Re: Mediterranean Village Review - #14153
Traffic Impact Study, Parking Analysis & Valet Operations Analysis

David Plummer and Associates (DPA) have completed several reviews of the Traffic Impact Analysis, Shared Parking Analysis, Parking Garage, and Valet Operation Analysis conducted for the proposed Mediterranean Village project. A summary of these components is below.

HOTEL DROP-OFF - OPTION #3 "STAFF RECOMMENDATION"

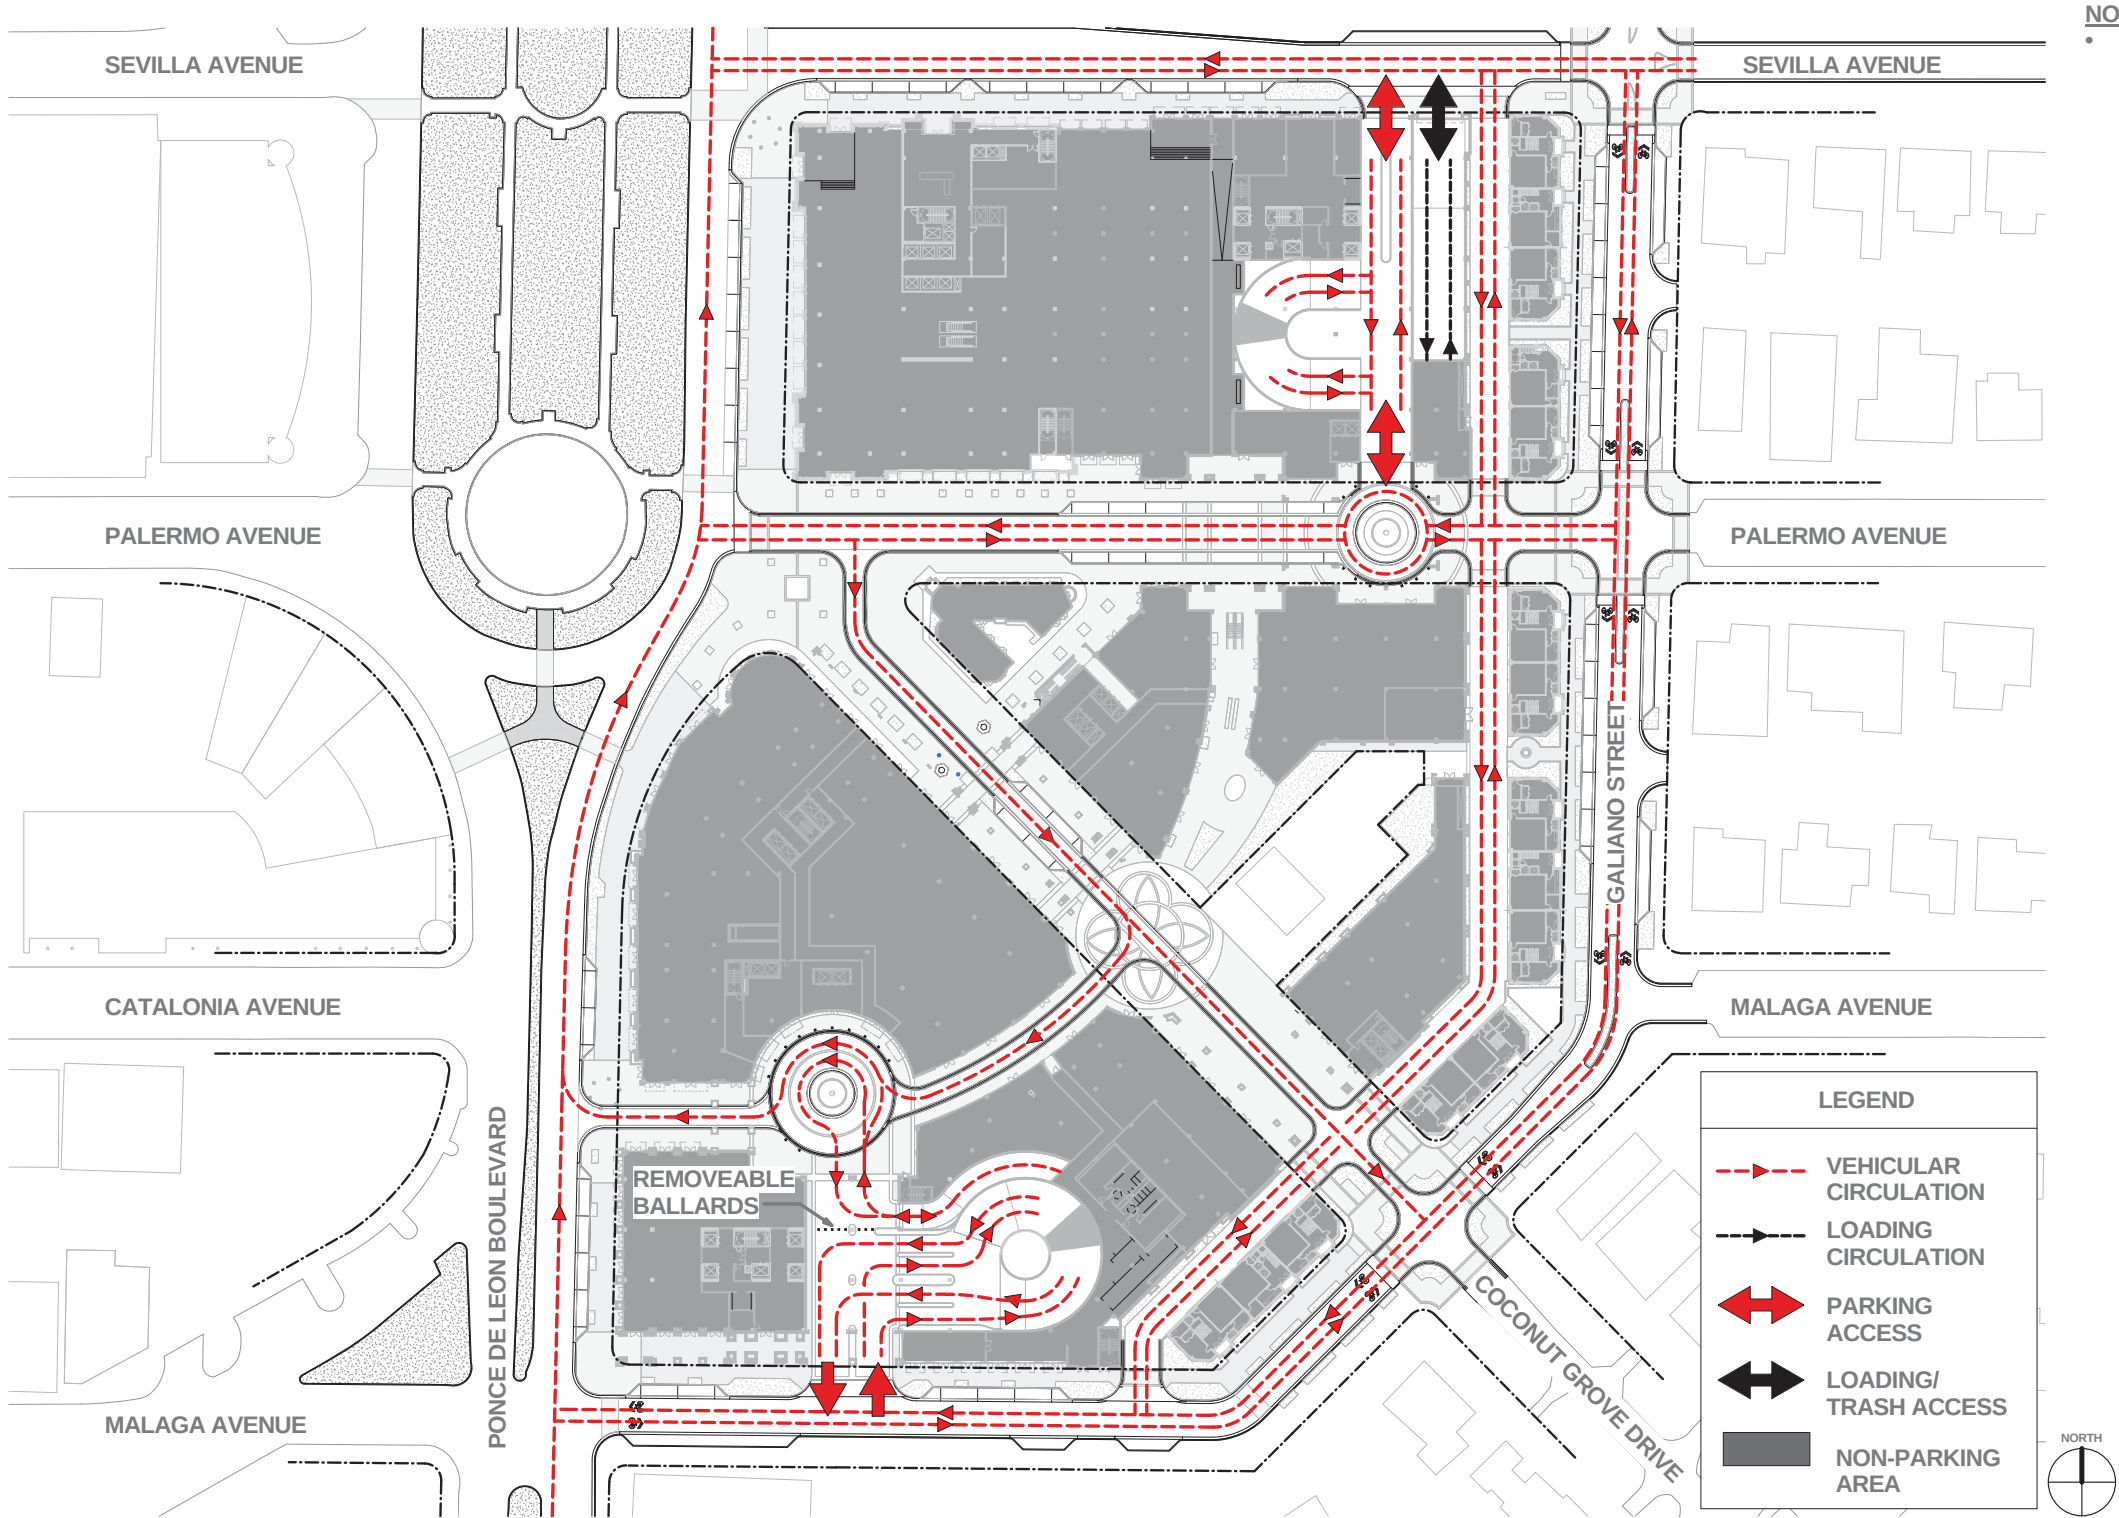
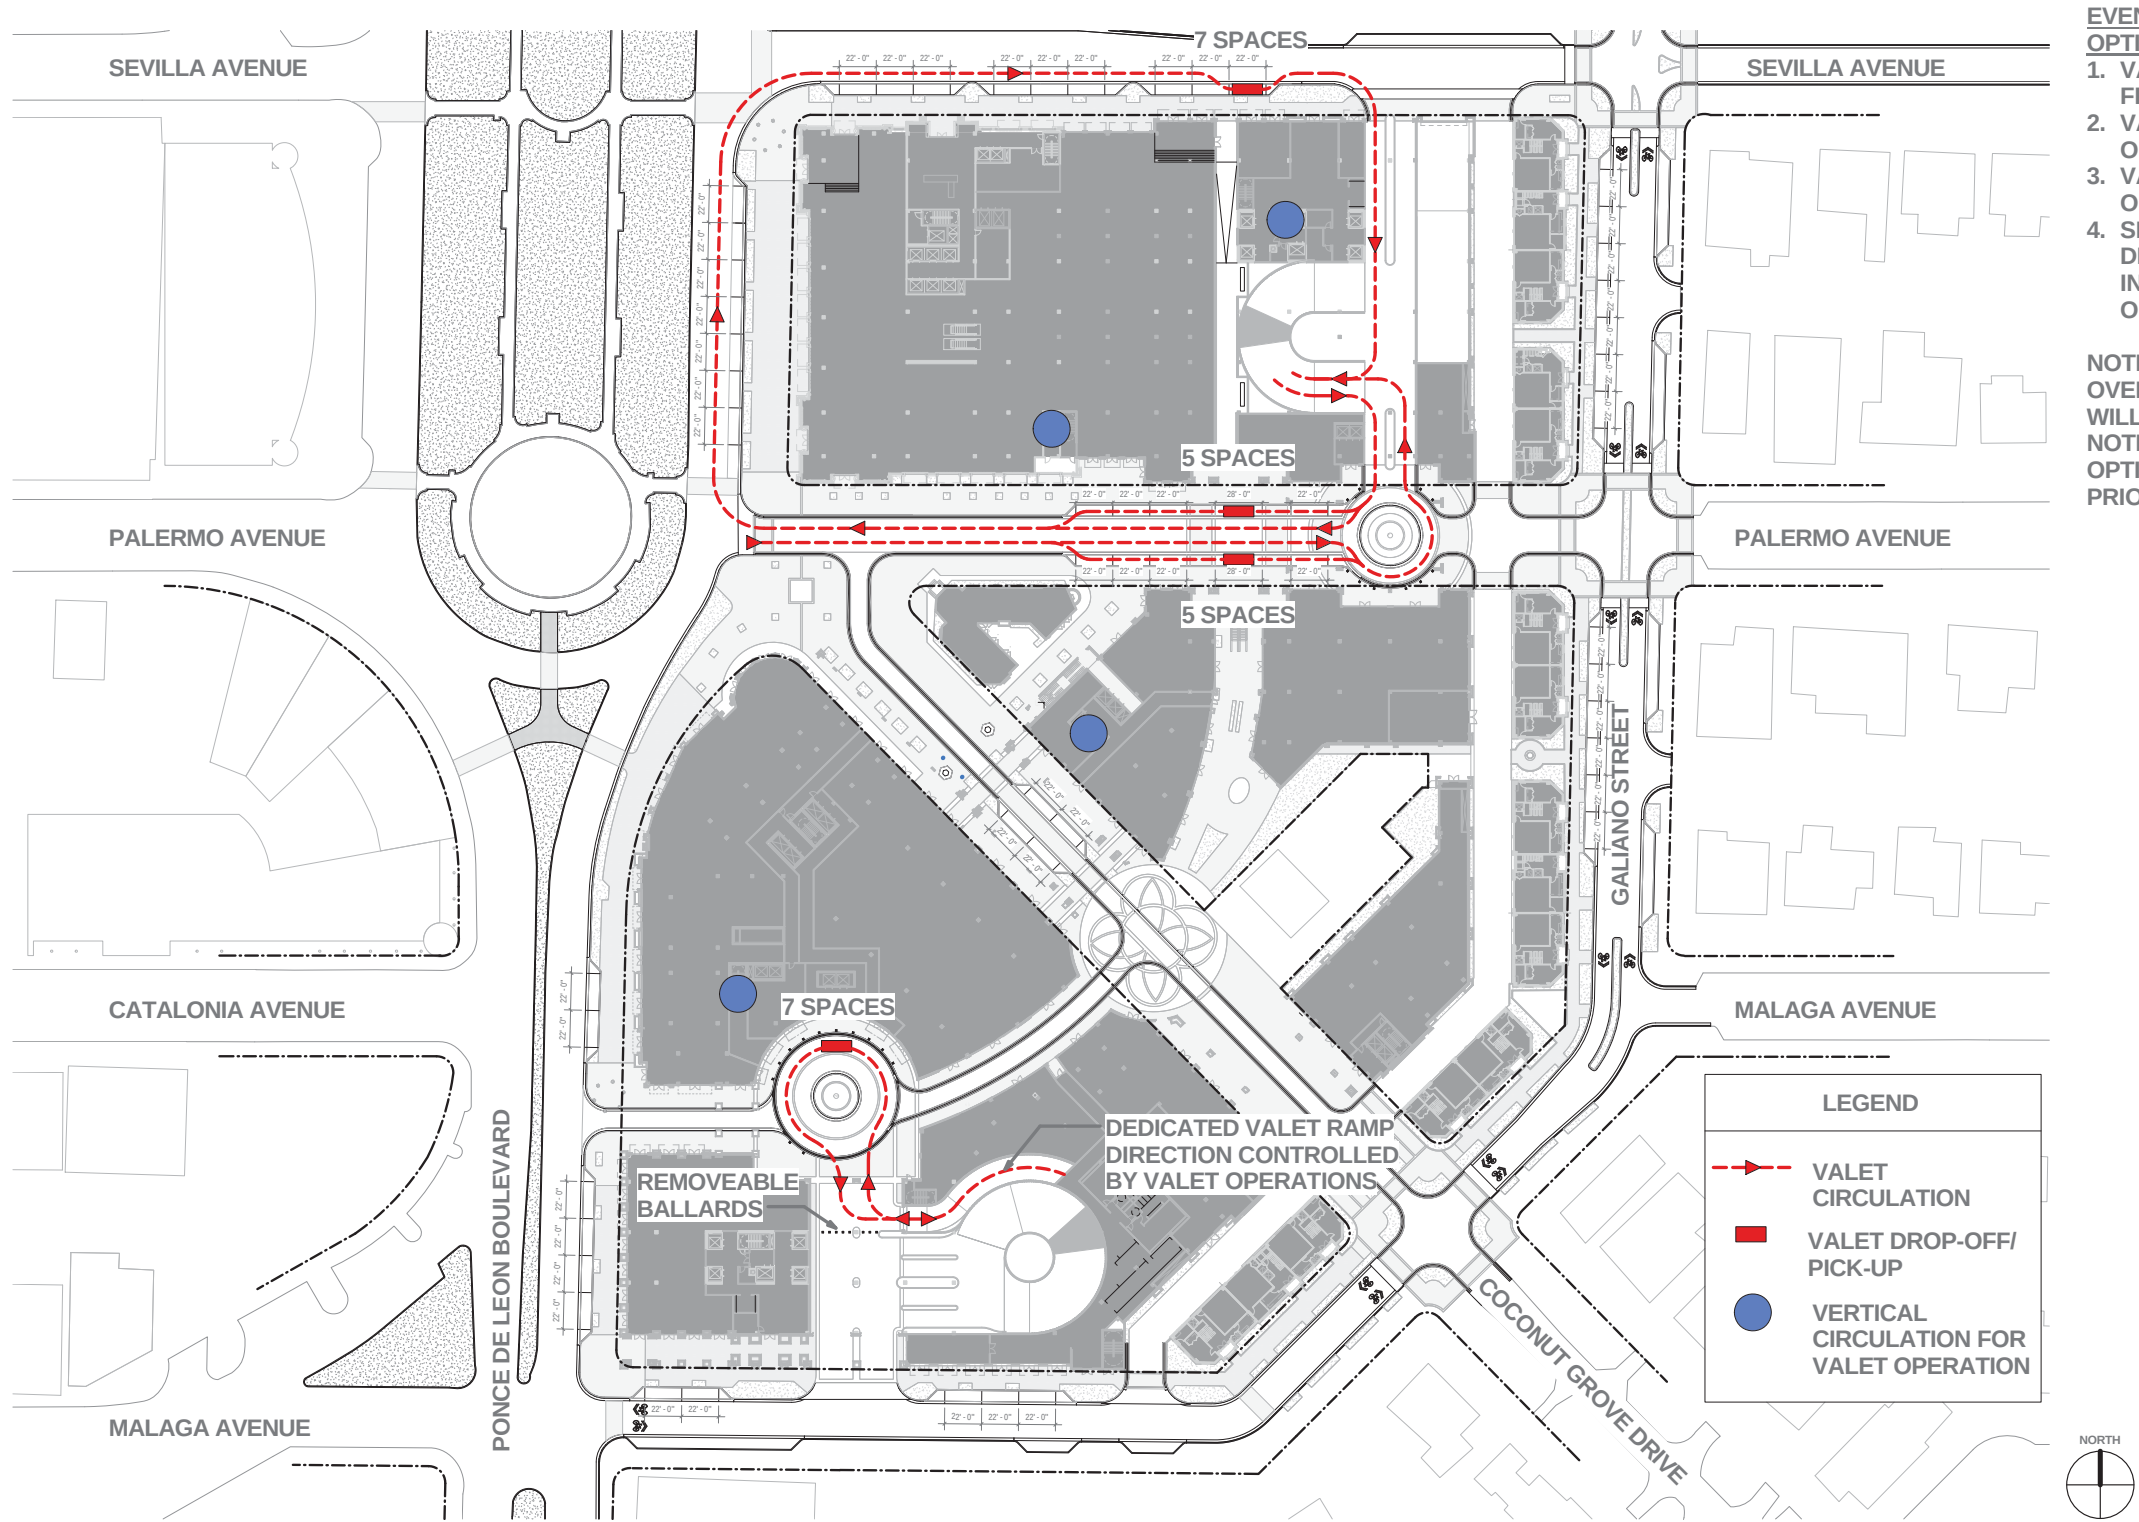
During first reading, the project included direct access to the hotel from Ponce. This access plan for the hotel was acceptable. The project has since changed to address comments from the Commission. Of the newly proposed options, Option 3 is an acceptable alternative and preferable to Option 2 provided that the following conditions are included: 1) the hotel valet ramps will be completely segregated from the Malaga driveway ramping system and no traffic from Malaga would be allowed to access the hotel's porte cochere, and 2) two one-way ramps (similar to the Ponce alternative) or a two-way, two-lane ramp for hotel valet use only is provided. See attachments for hotel access options.
